RE: Docket No. 04008904 1800, Responses to July 26, 1988 NRC Comments

INTERA RESPONSE TO NRC COMMENTS OF JULY 26, 1988

REDESIGN OF COVER SWALES USING NUREG/CR-4651 CRITERIA
L-BAR URANIUM OPERATIONS RECLAMATION PLAN

CALC. 84-103. CB Rev. 1

FIGURE 64-103, C 8.3

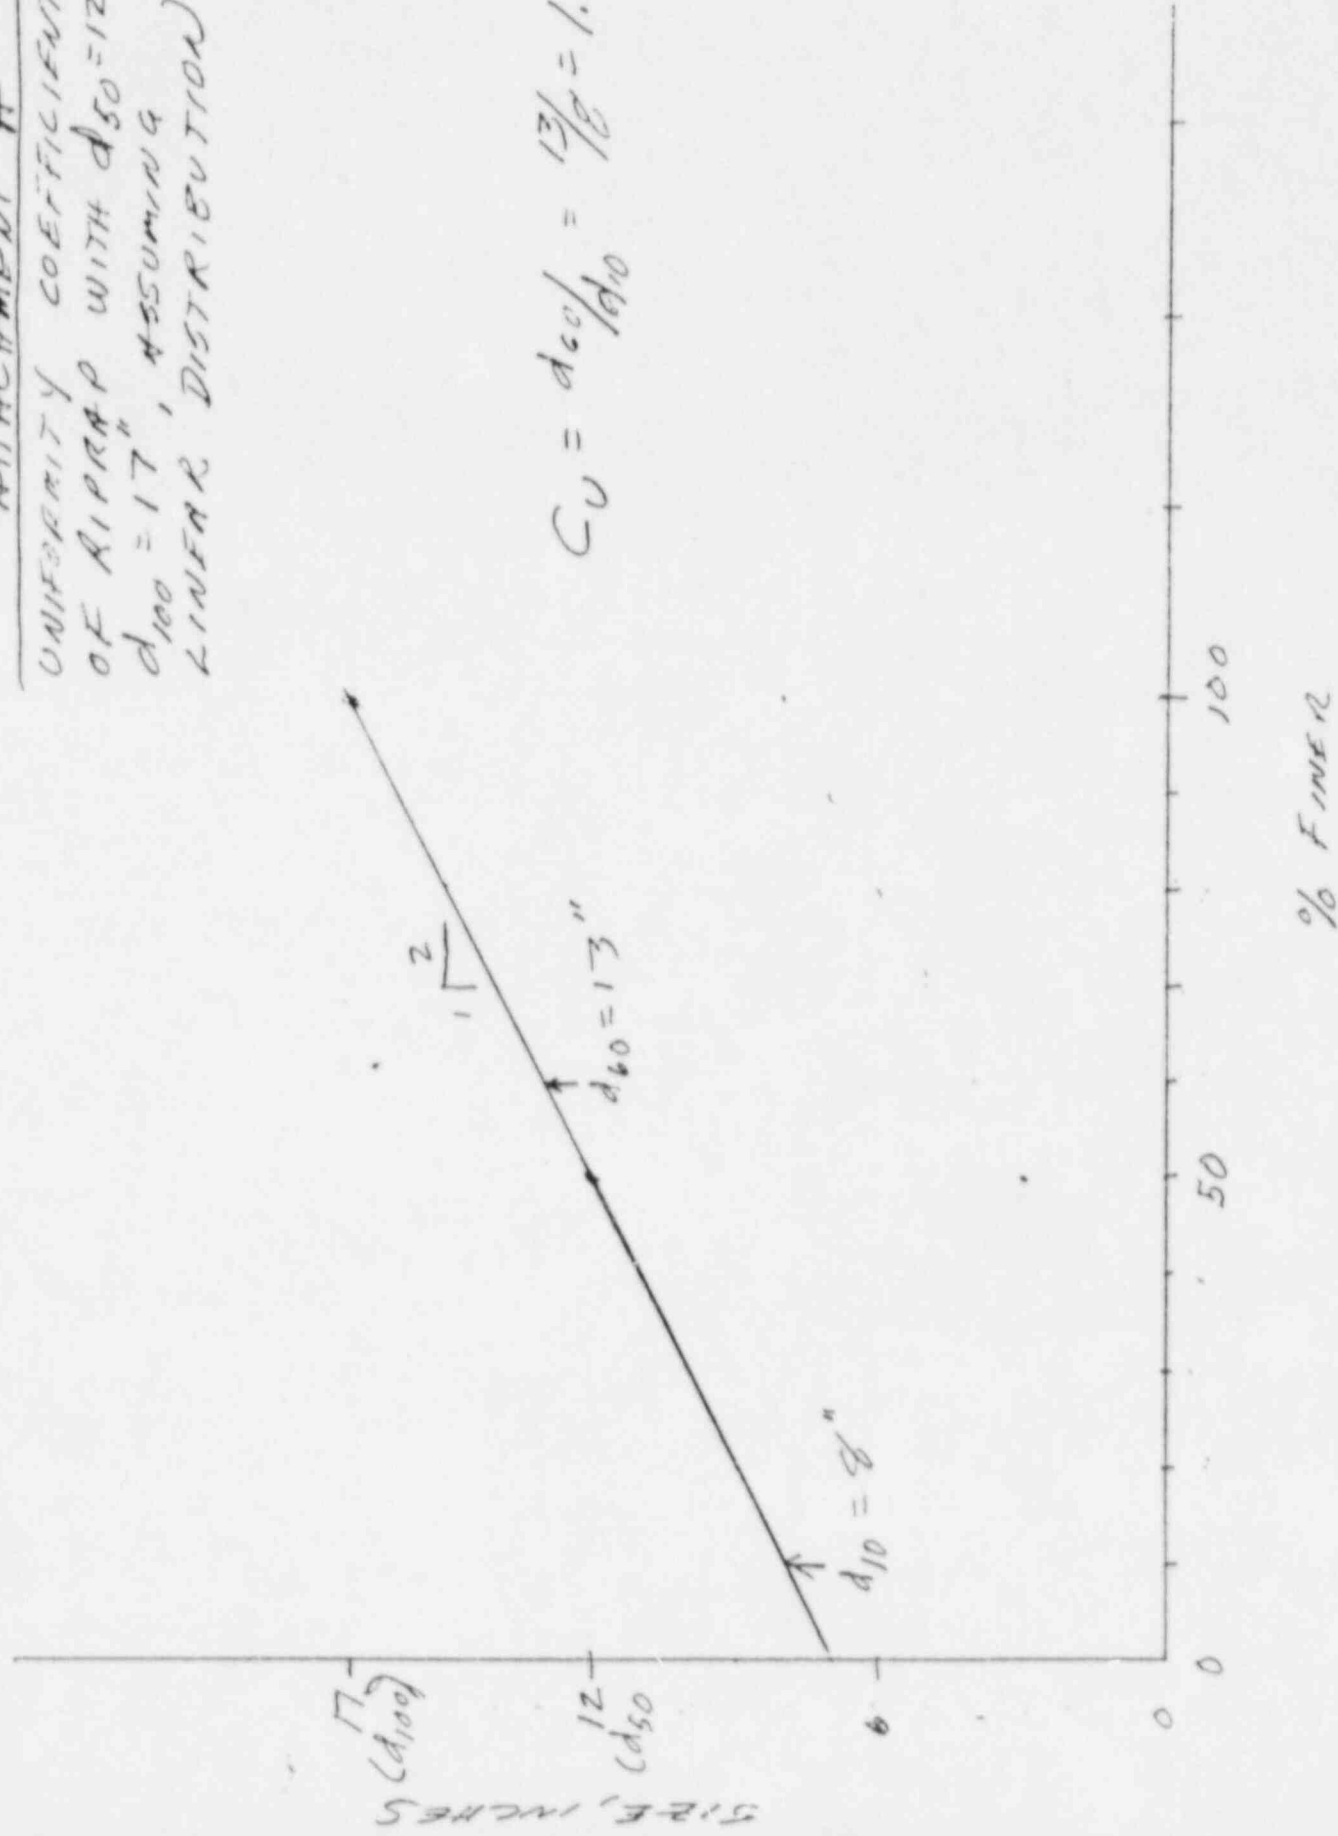
The design basis flood used to design the shape of the top of the pile and the swale where the flood passes over the impoundment was not conservatively derived. Based on our independent evaluations, the proposed rock size for the swale would not be adequate. The design basis flood should be recalculated, as we have discussed with your consultant, and the swale redesigned. The changes in the design could include increasing the size of the rock, widening the swale, or a combination of these. Also, you may wish to consider redesigning the top to eliminate the swale and instead, direct flows over the entire length of the embankment outslopes. This option, however, would necessitate that the rock size on the embankment outslopes be increased to accommodate the larger design flows.

The design basis flood of the top of the pile has been recalculated using an ultraconservative runoff coefficient of 1.0. As a result the cover swale has been redesigned and the rip rap criteria of NUREG/CR-4651 have been incorporated. The calculation and sketches for this redesign are enclosed.

section, to provide smooth,
gradual changes from radially
converging flow to channelized
flow in control section
per Figures 84-103.C8.3, C8.4,
and C8.5)
